RE: Preliminary Adequacy Response (AM-05), Pueblo East, Permit No. M-1986-015

Following are our responses to the Division of Reclamation, Mining and Safety's (DRMS) comments on our Amendment Application, AM-05 for the Pueblo East Permit, Permit No. M1986-015.

EXHIBIT F-2
RECLAMATION PLAN

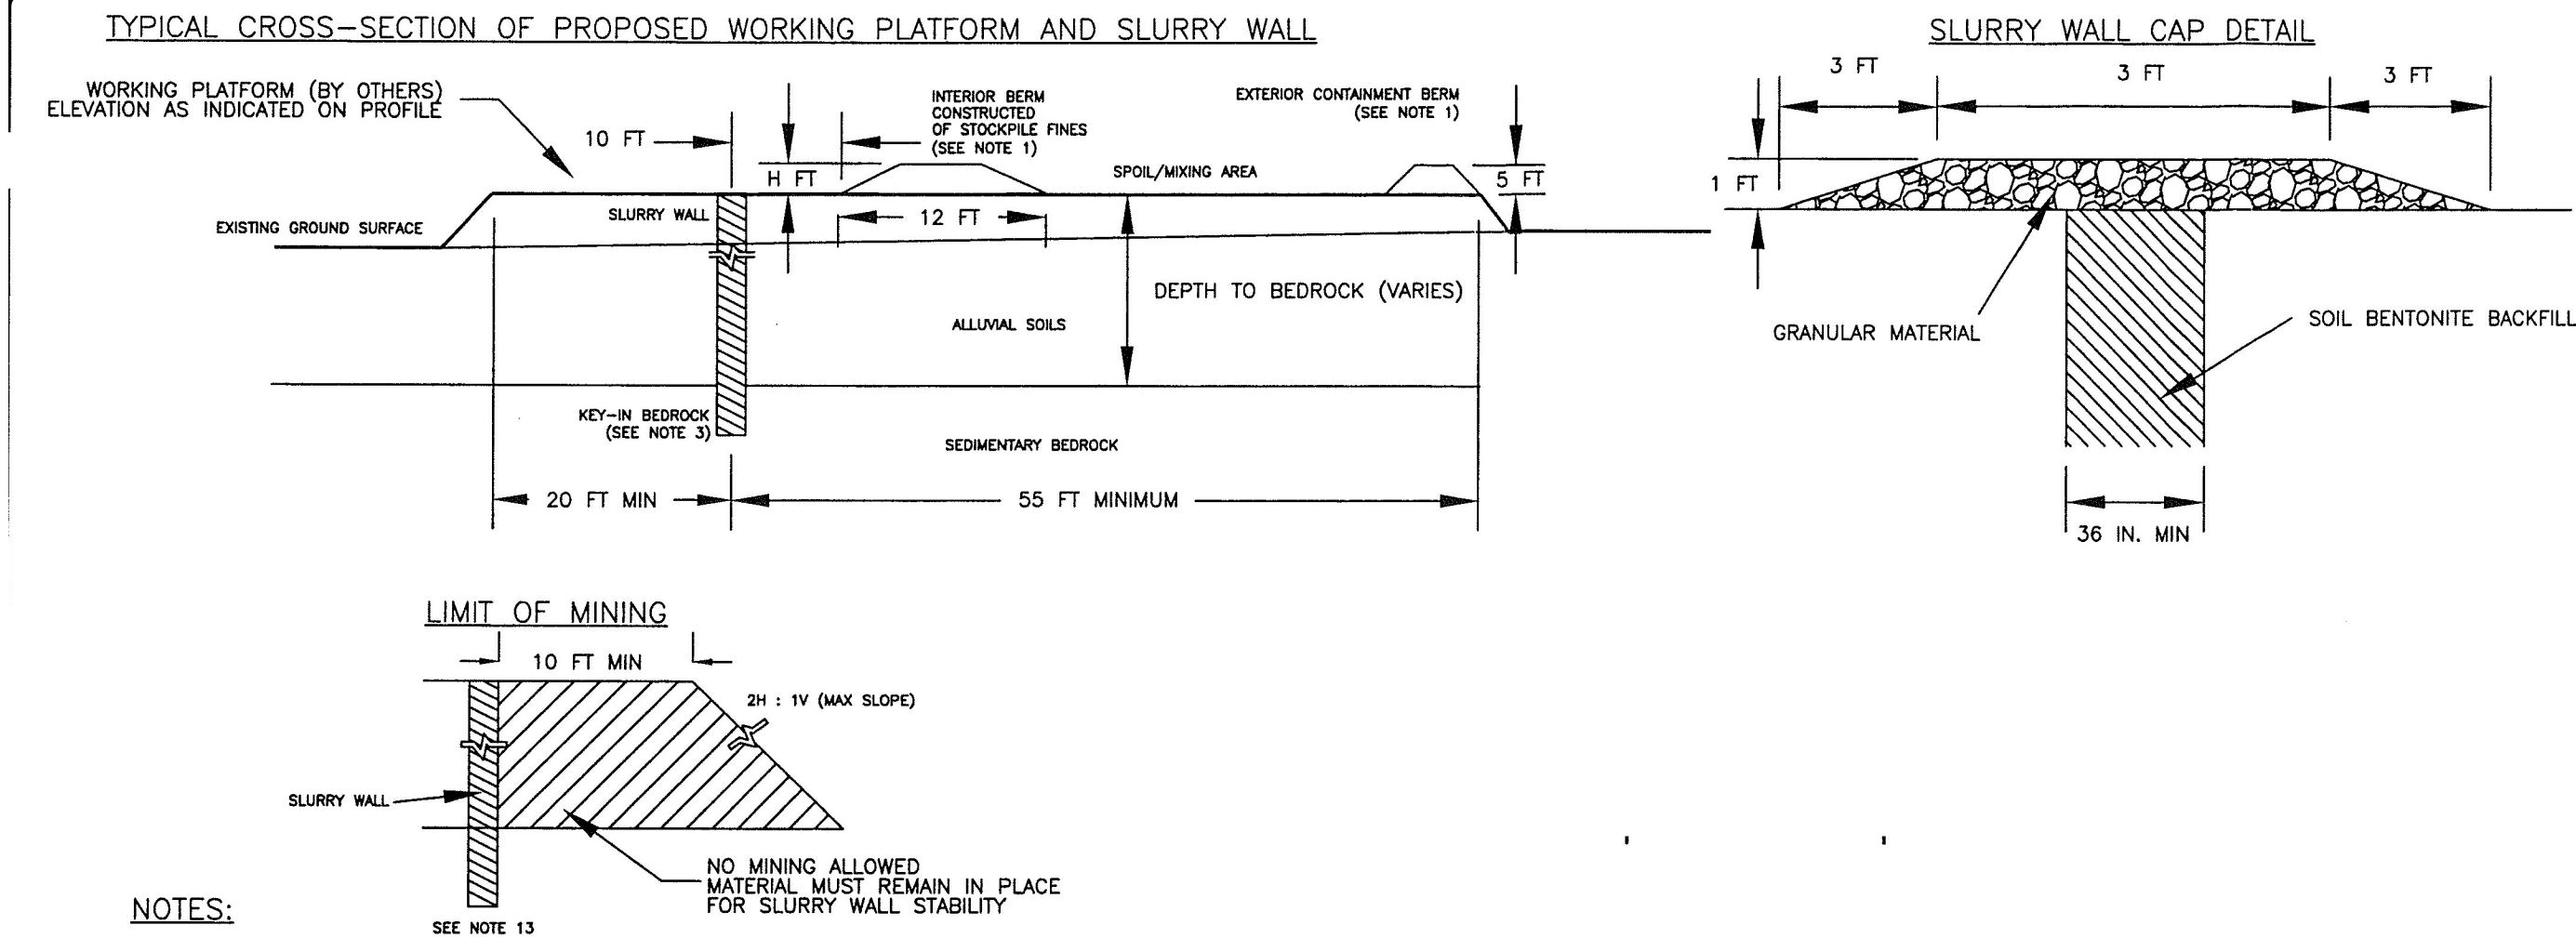
- 24. *Phase 1 Area – Please provide a summary of the proposed slurry wall in this exhibit as in Exhibit G.*
 - Response: The proposed slurry wall is shown on Map F-1 and details follow on exhibit F-2.
 - ✓
